HISTORIC AND DESIGN REVIEW COMMISSION

April 15, 2015

HDRC CASE NO: 2015-143
ADDRESS: 8514 MISSION RD
LEGAL DESCRIPTION: NCB 11175 BLK LOT NW IRR 862.87 FT OF TR 12 (ARB 12C)
ZONING: R6 H RIO-6
CITY COUNCIL DIST.: 3
DISTRICT: Mission Historic District
APPLICANT: Clay Hagendorf
OWNER: City of San Antonio, Aviation Department
TYPE OF WORK: Parking lot improvements
REQUEST:

Construct a new parking lot at the Stinson Airport to replace an existing informal parking lot.

1 SITE PLAN
 sc. 1" = 20'-0"
 NEW CONSTRUCTION

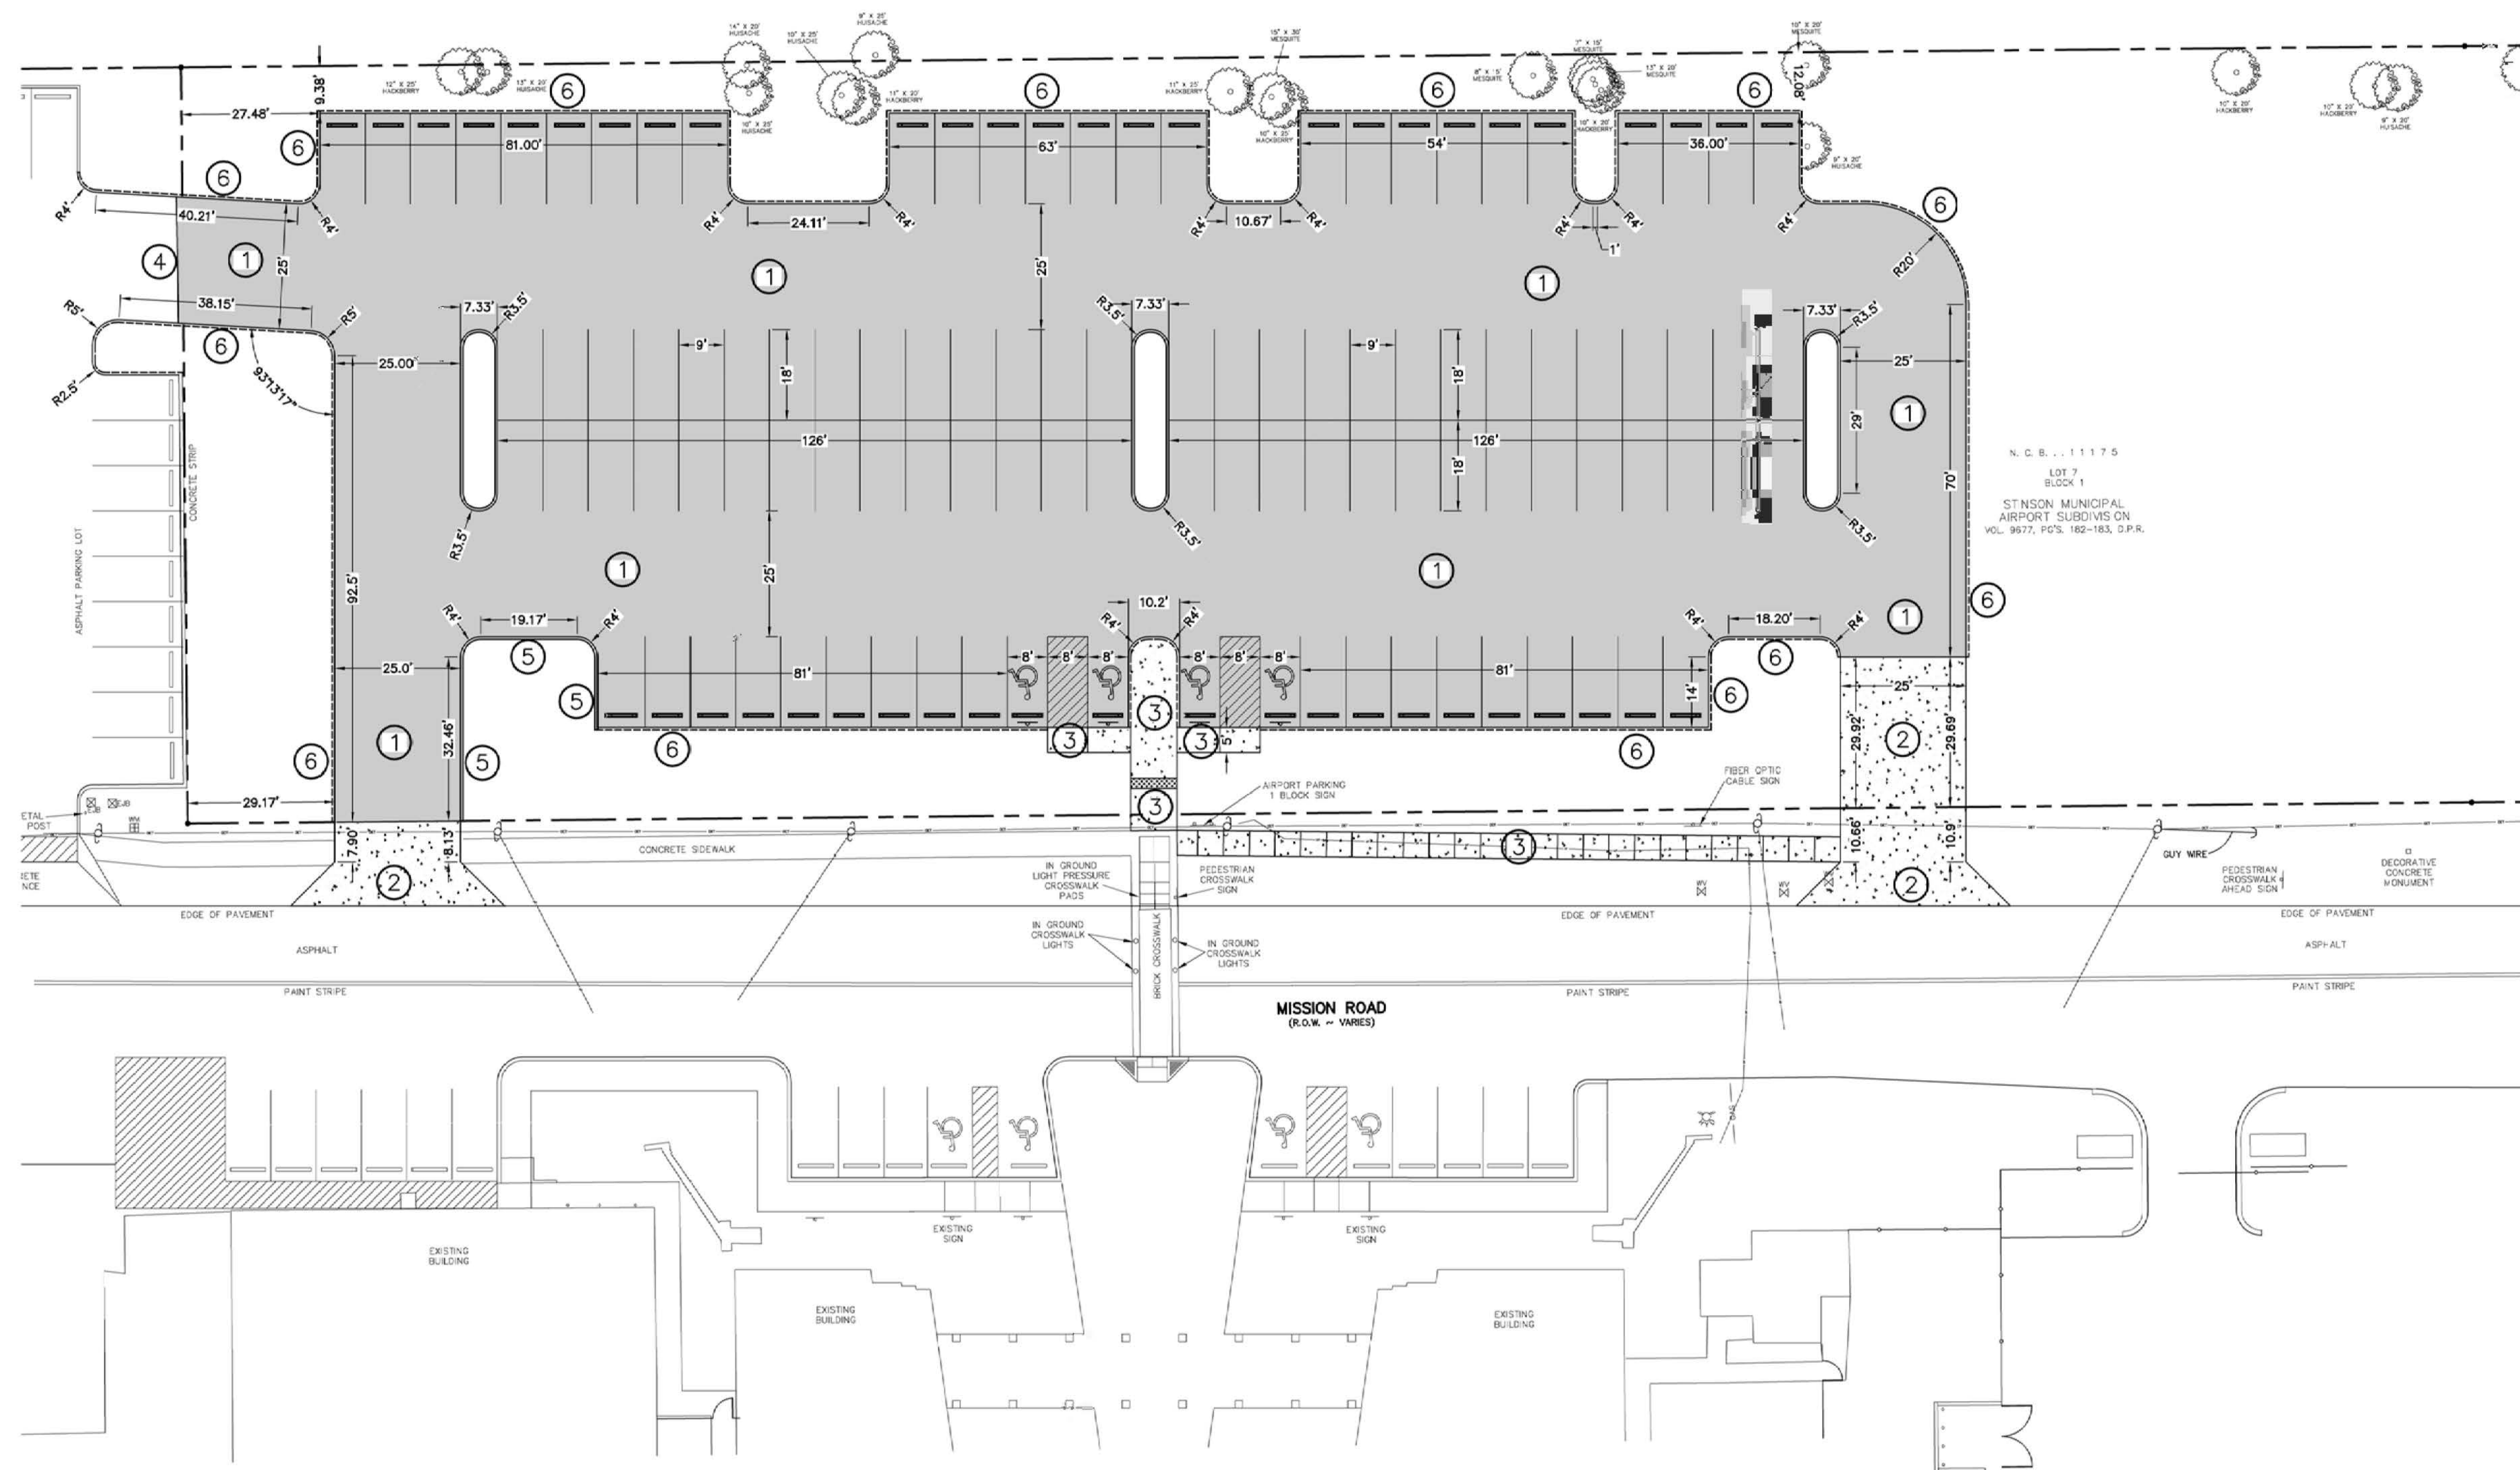
- b. The applicant has proposed two curb cuts to provide automobile access to the proposed parking lot. This is consistent with the UDC Section 35-672(b)(1) regarding automobile parking and curb cuts.

L1.1

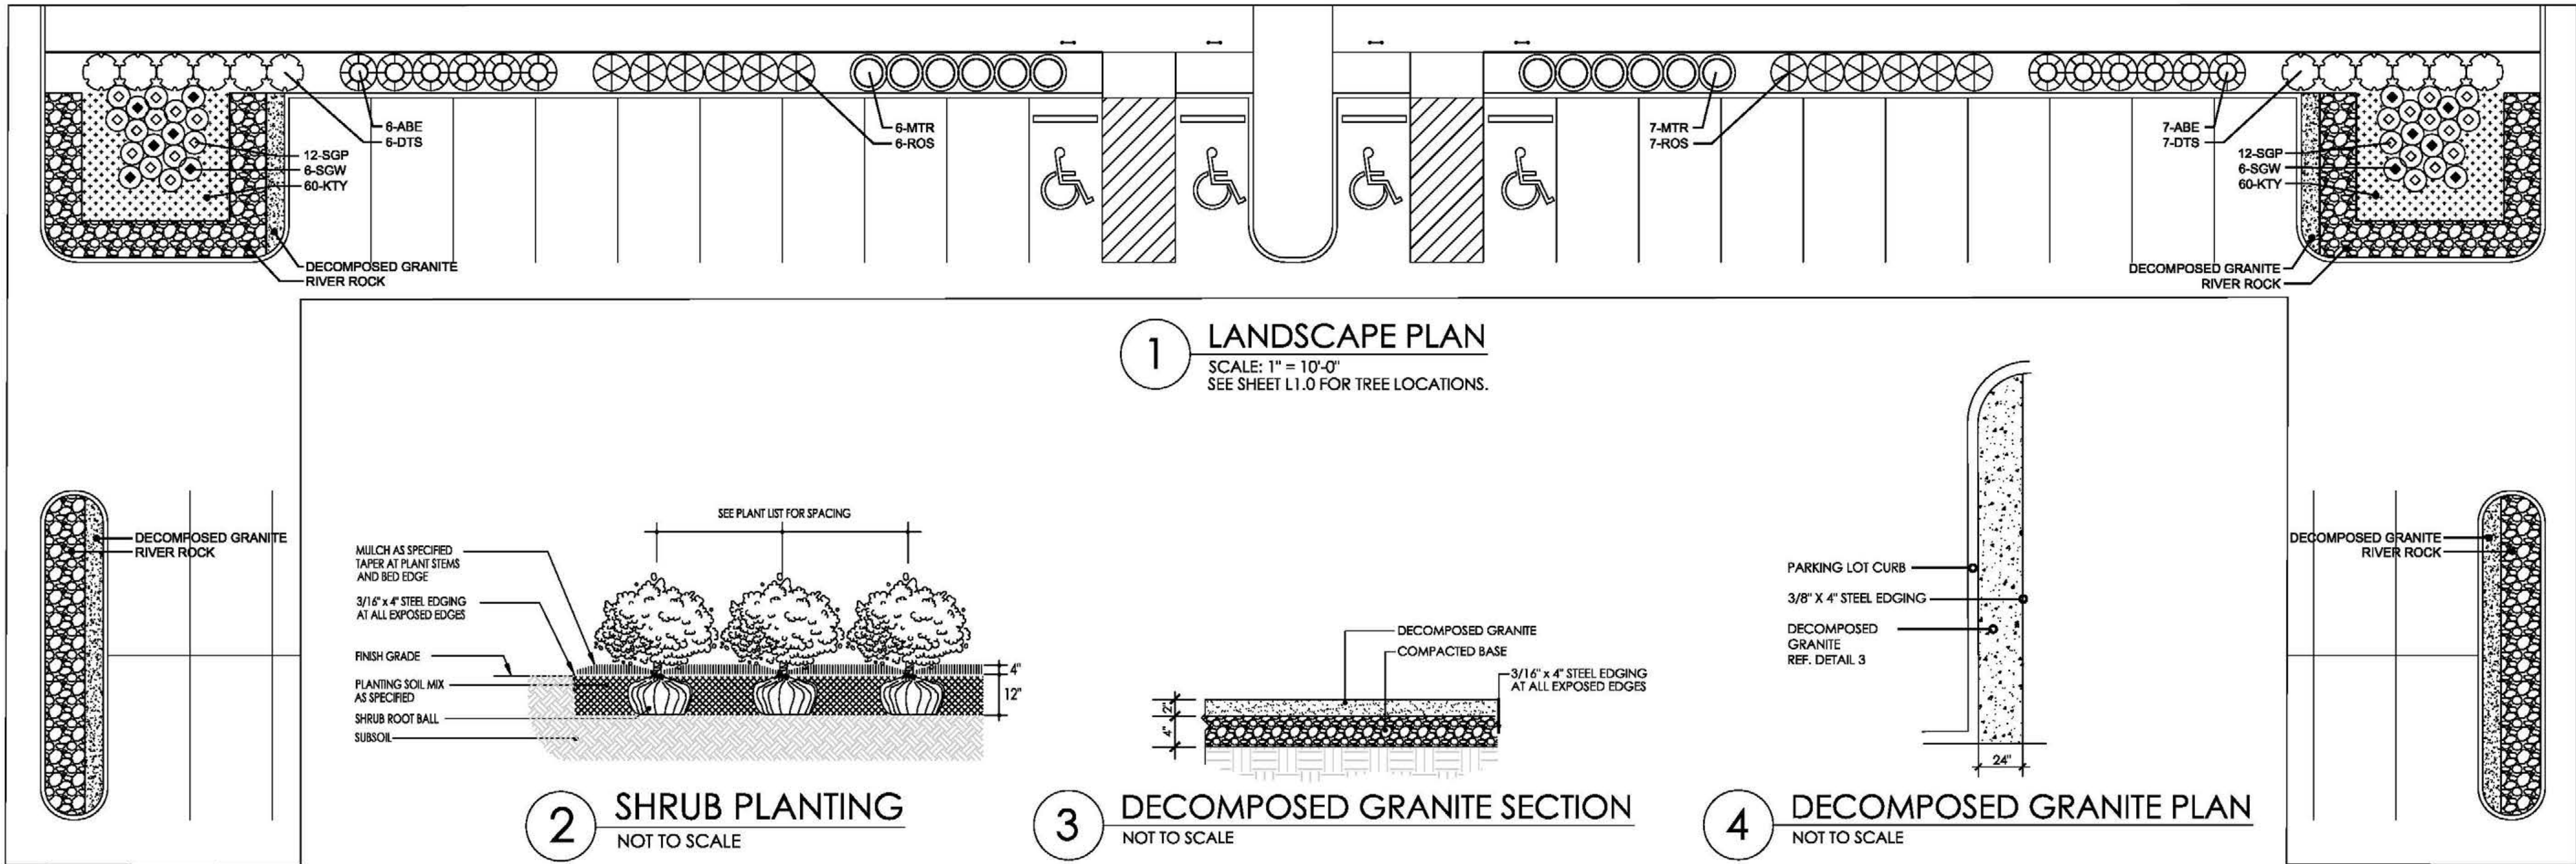
- c. The applicant has provided a landscaping plan which includes a tree preservation plan, specifics on planting materials and information regarding the buffering and screening of parking from the public right of way. This is consistent with the UDC Section 35-672(b)(3).

- d. According to the Historic Design Guidelines, Chapter 5, Guidelines for Site Elements, planting should be incorporated into the design when rock or gravel is used in place of a lawn area. The applicant has proposed to provide xeriscape planting at locations shown in the provided site plan including decomposed granite and river rock at various curb locations. This is consistent with the Guidelines for Site Elements. In regards to appropriate plant material, the applicant is to comply with the UDC Appendix E: San Antonio Recommended Plant List—All Suited to Xeriscape Planting Methods.
